Furman Sound Inc.		1997 S. McDOWELL BLVD PETALUMA, CA 94954 TEL: (707) 763-1010 FAX: (707) 763-1310	
HDS6			
Doc. No. 1	PCB 343141-2074	Drawn By BM 10/02/97	
Sheet 1 Of 6	LBR 380500-2075	Date Printed 13-Sep-2002	
Rev D 02/10/98 BM	ASY 390500-2076	Time Printed 13:55:56	
File P:\HDS-6\SCHREV.D\HDS6_D.PRJ

HDS6 MAIN BOARD		FURMAN SOUND, INC 1997 S.McDOWELL BVD, PETALUMA, CA 94954 TEL: (707) 763-1010 X 39 FAX: (707) 763-1310	
ASY 390500-2076		SHEET 1 OF 1	DRAWN BY: BM
LBR 380500-2075			
PCB 343141-2074	REV D 2/10/98 BM	-HDS6_D NET LISTS

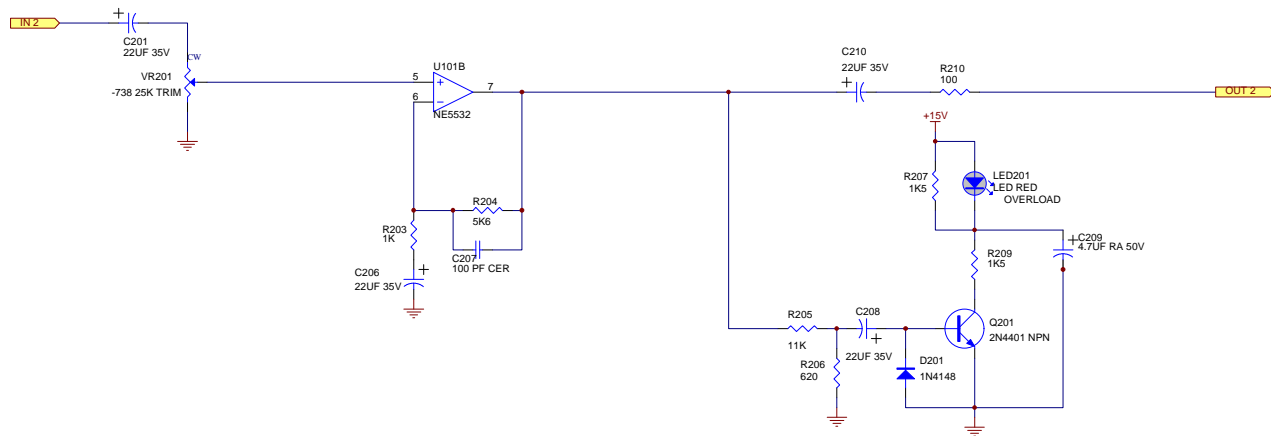
NOTES
 2/24/98 BM- CHANGED JP2 AND JP3 FROM 0 OHM JUMPER TO 2R2 FOR PROTECTION OF REG. TRANSISTORS
 18 March 1998 JM changed values of overload resistors R705 and R708

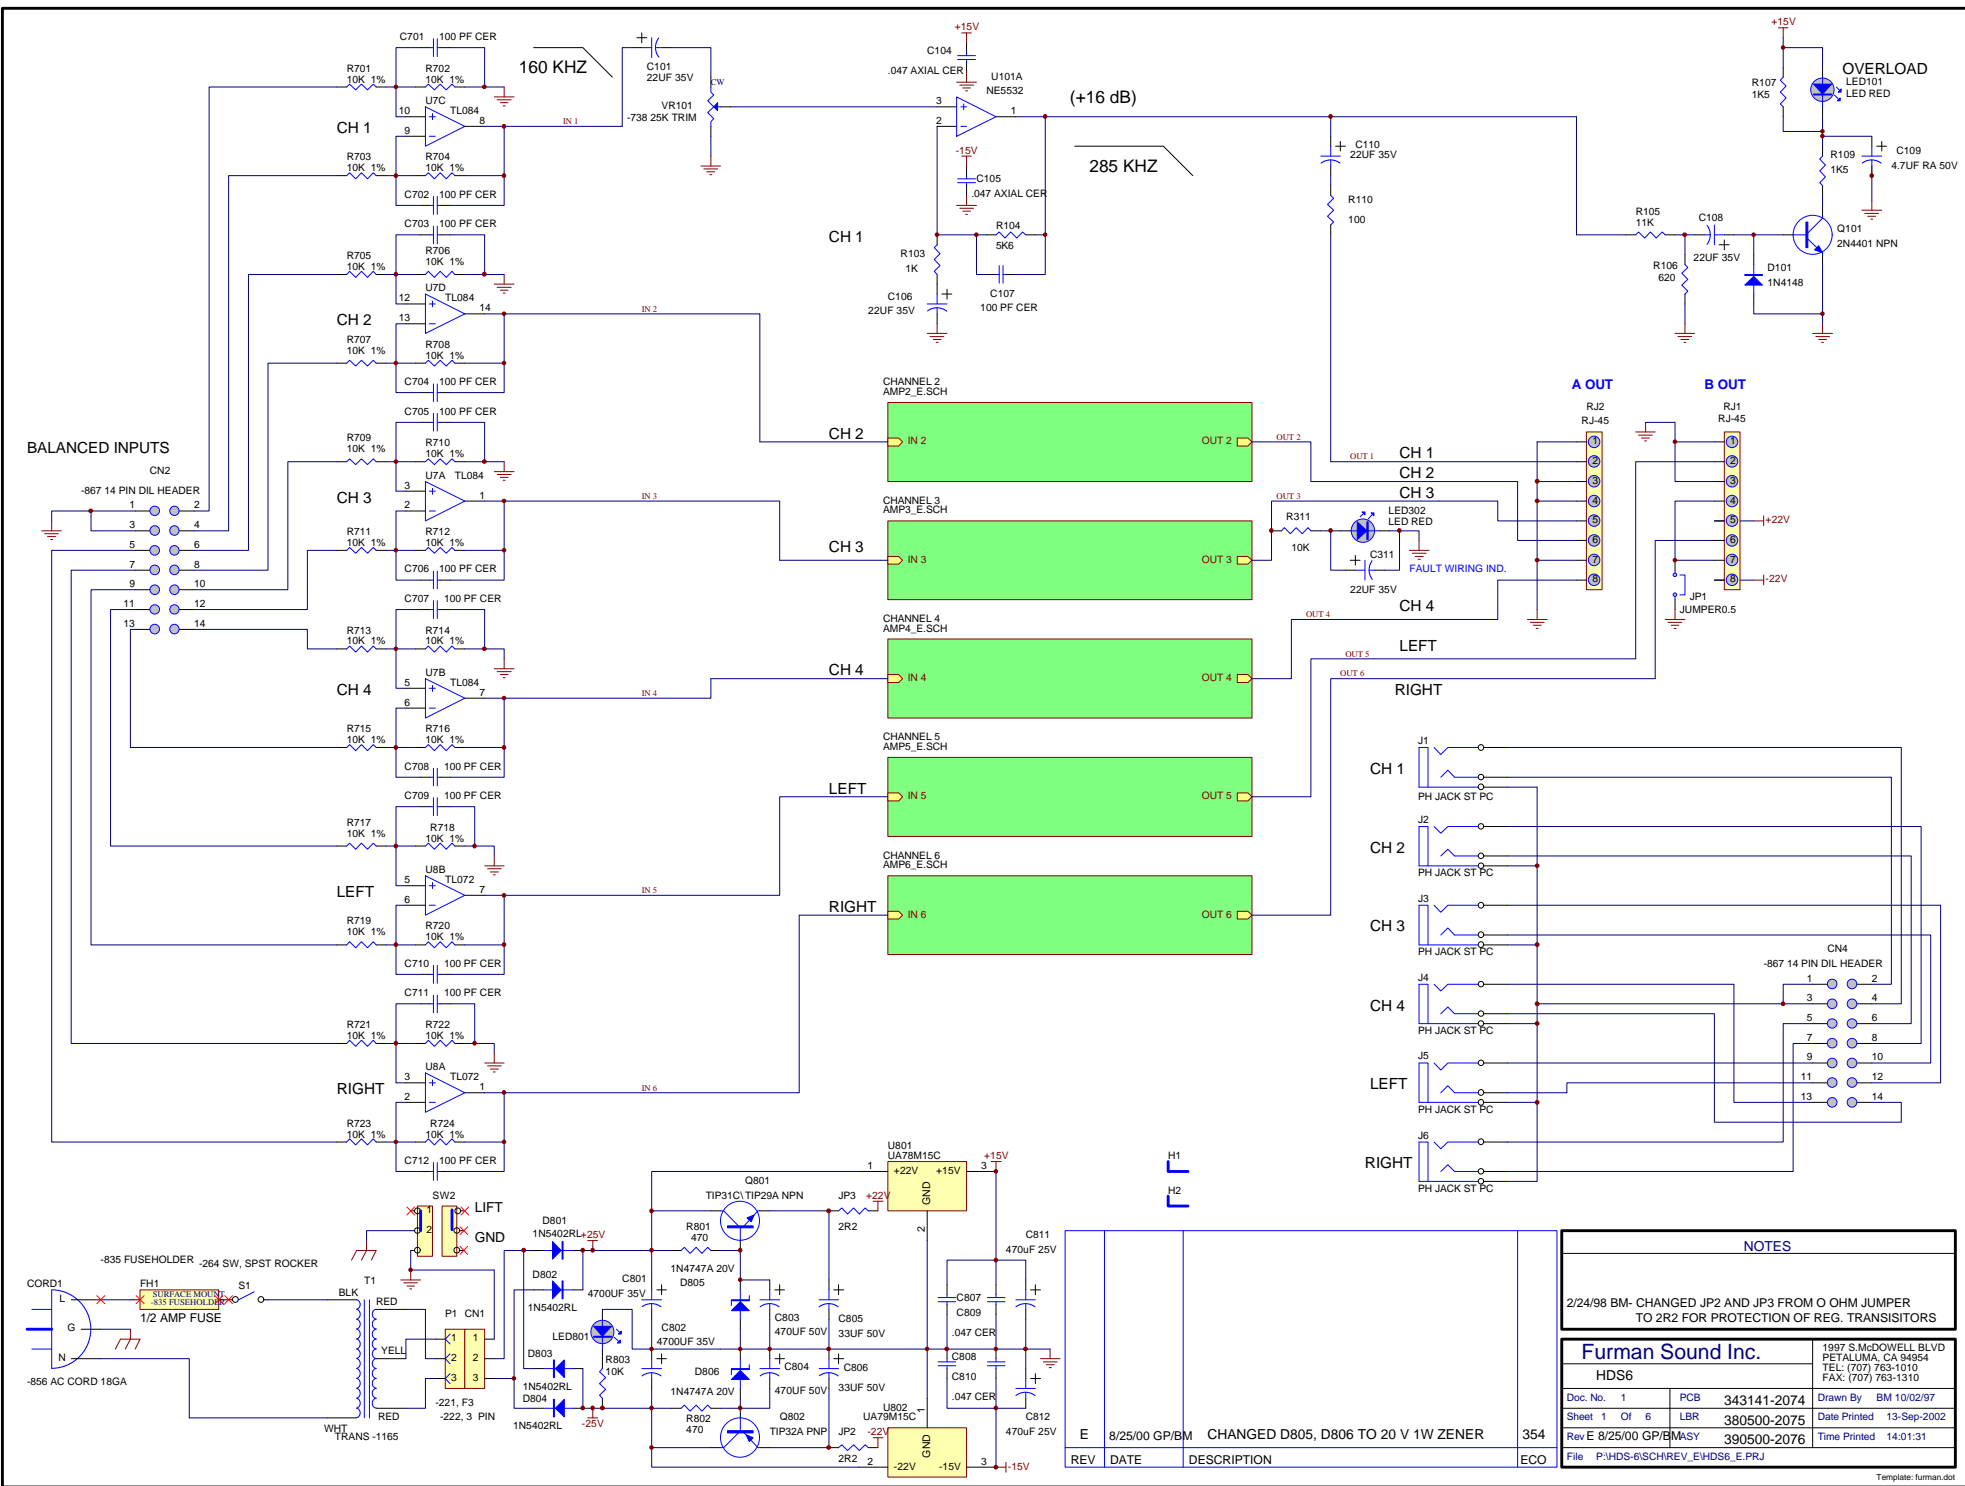
2/24/98 BM- CHANGED JP2 AND JP3 FROM 0 OHM JUMPER TO 2R2 FOR PROTECTION OF REG. TRANSISTORS

E	8/25/00 GP/BM	CHANGED D805, D806 TO 20 V 1W ZENER	354
REV	DATE	DESCRIPTION	ECO

Furman Sound Inc.		1997 S. McDOWELL BLVD PETALUMA, CA 94954	
HDS6		TEL: (707) 763-1010	
Doc. No. 1	PCB 343141-2074	Drawn By BM 10/02/97	
Sheet 1 Of 6	LBR 380500-2075	Date Printed 25-Mar-2003	
Rev F	ASY 390500-2076	Time Printed 07:36:34	
File G:\HDS-6\SCH\REV_F\HDS6_F.PRJ

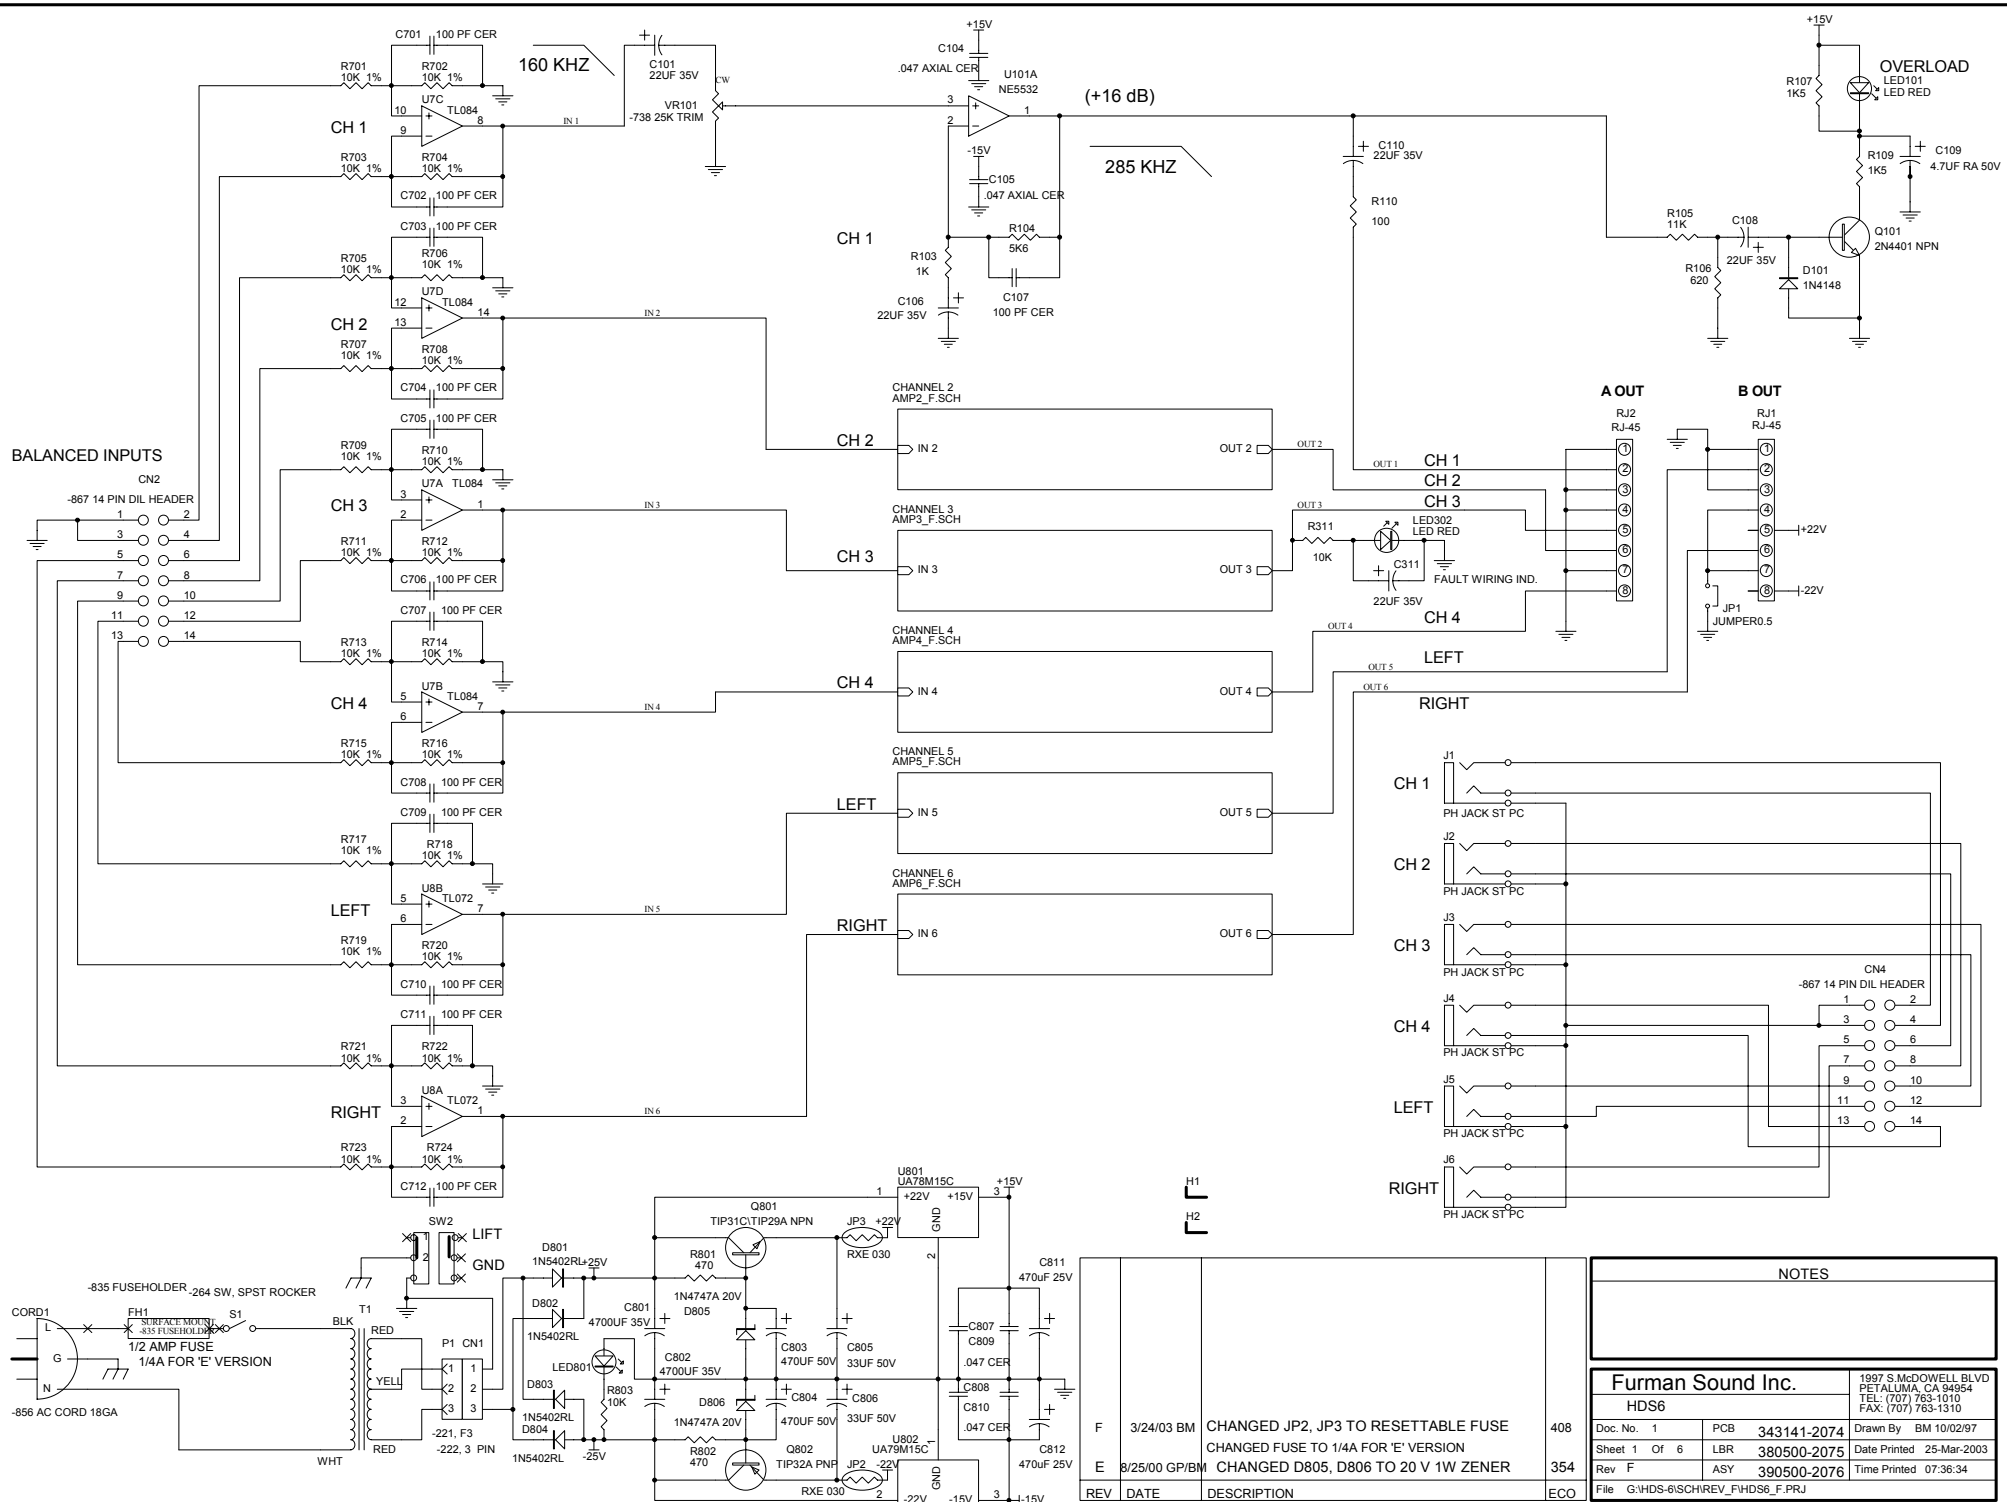
REV	DATE	DESCRIPTION	ECO
F	3/24/03 BM	CHANGED JP2, JP3 TO RESETTABLE FUSE	408
E	8/25/00 GP/BM	CHANGED FUSE TO 1/4A FOR 'E' VERSION	354
		CHANGED D805, D806 TO 20 V 1W ZENER

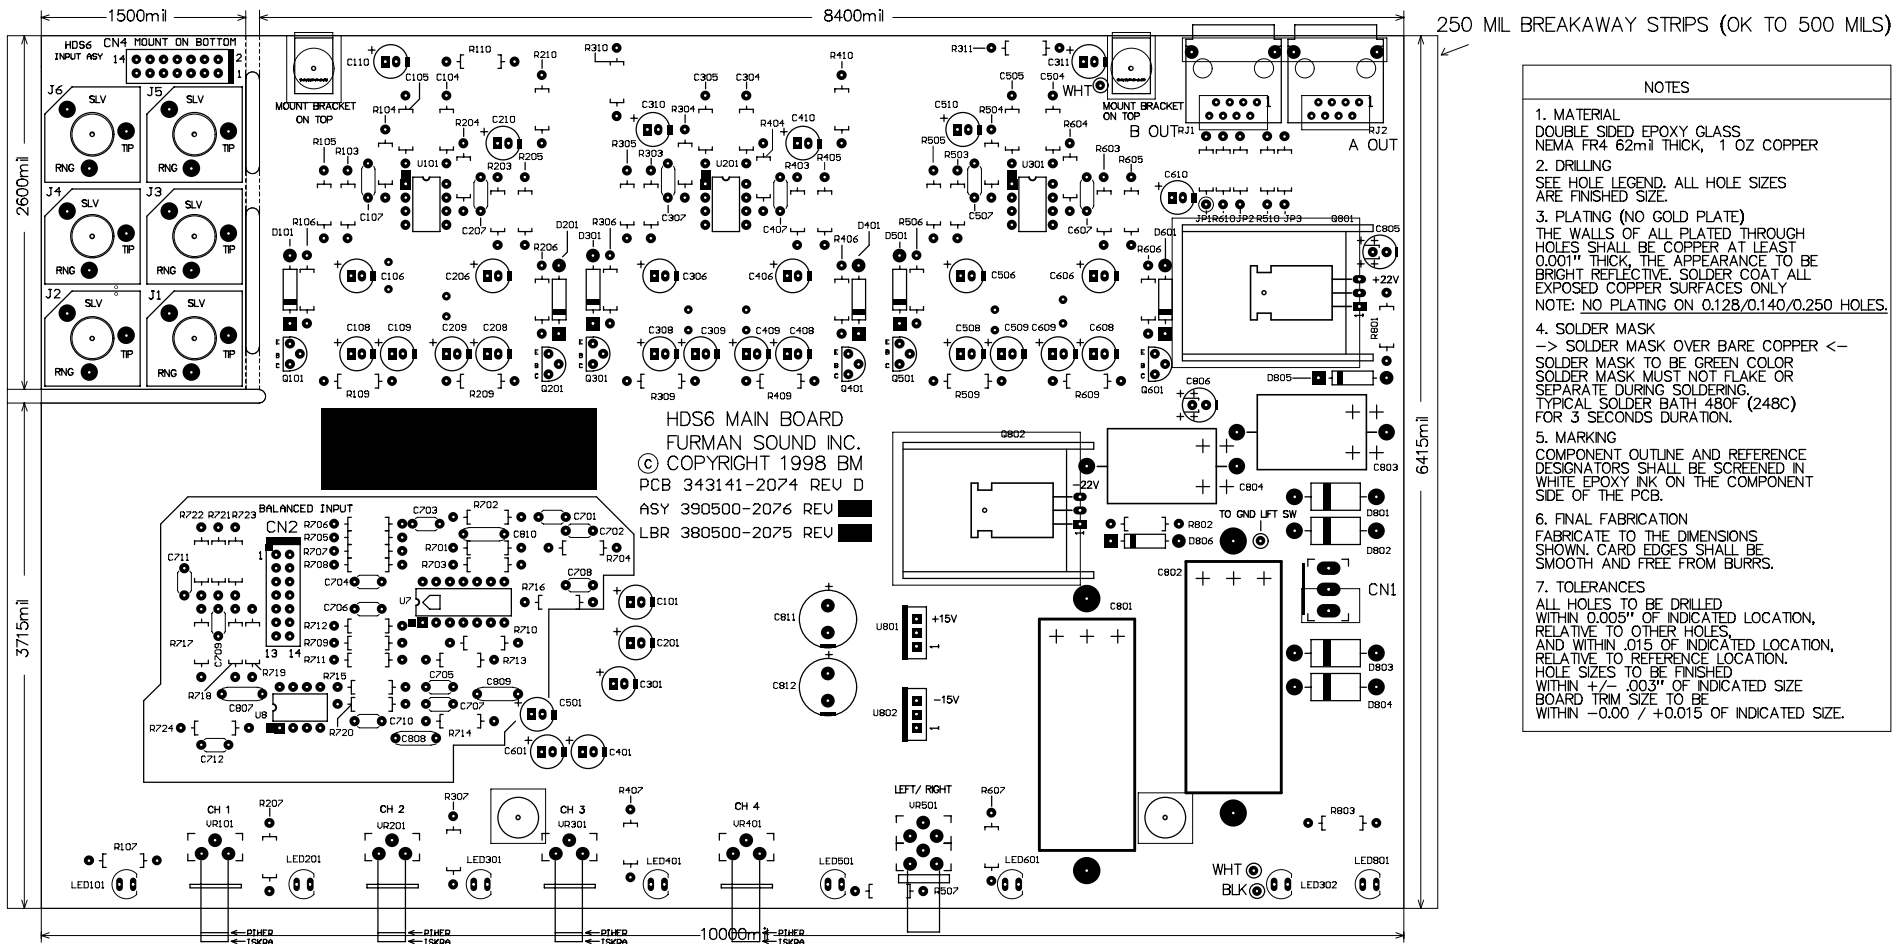
THERE IS AN ERROR ON TWO VIA HOLES BETWEEN J1 & J2
 BESK WILL ADD TEAR DROP TO THE PADS TO FIX THE BOARD
 REV E WILL BE CORRECTED. 2/20/98 BM
